HDS - SPEAKER KITS - S200W subwoofer amplifier input sensitivity mod

APPLICATION NOTE:

Fig 1 Pre Amp PCB

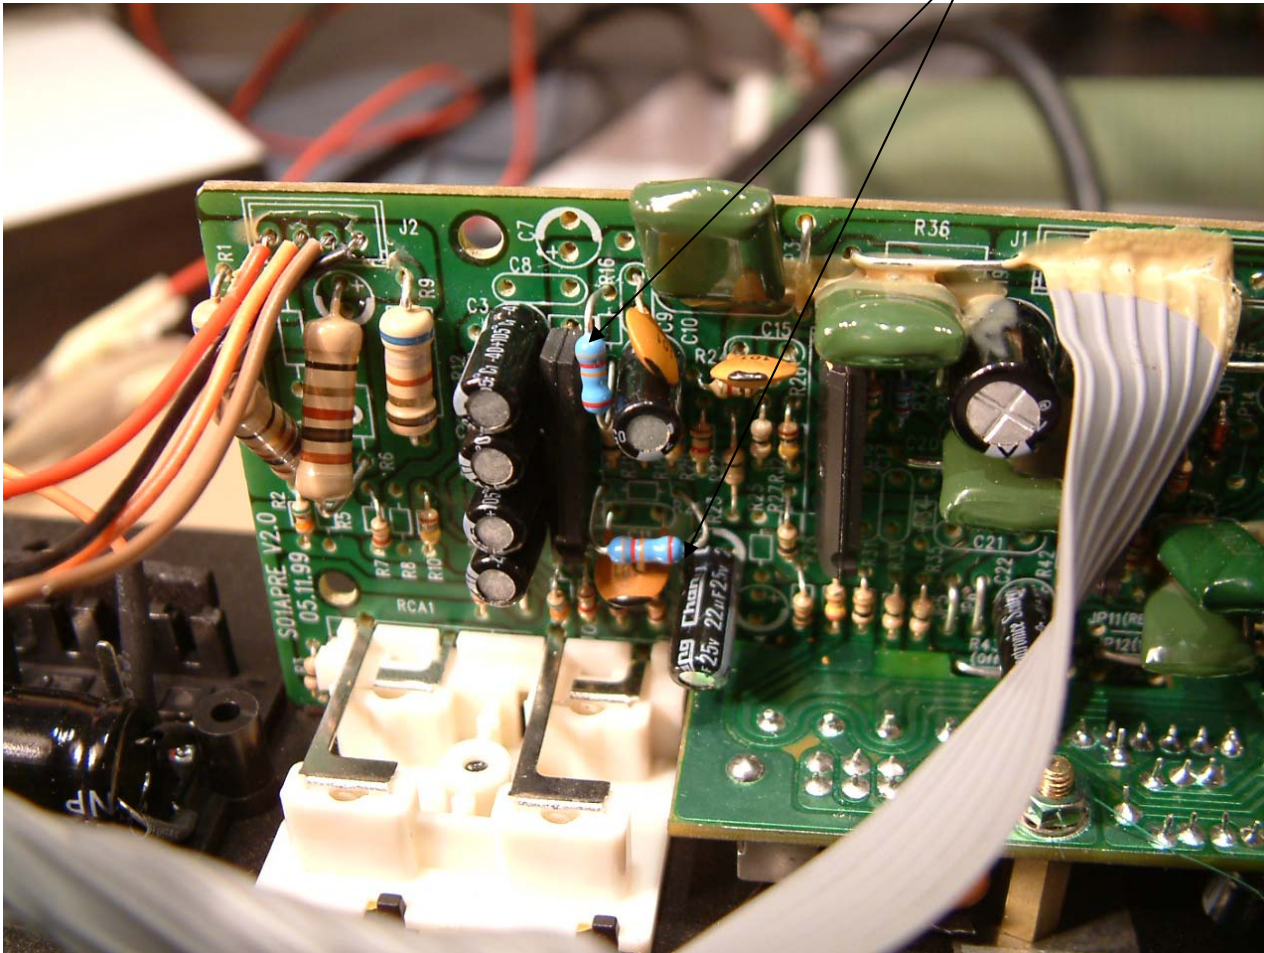
The replacement P830667 has a lower SPL sensitivity than the original 8" P830491 subwoofer.

Problem :It has been found when using the P830667 8" with the S200W subwoofer amplifier the amp Level control will need to be increased between ¾ to max volume to achieve sufficient sound level with some Hometheatre Speaker systems .

I recommend increasing the S200W amplifier input sensitivity to match the new P830667 8" driver in the XLS800 Speaker Kits (OR) in DIY P830667 +S200W combo's sold by WES. See Figs 1 & 2 below .

Change feedback resistors from 12k (0.25w) to 82K
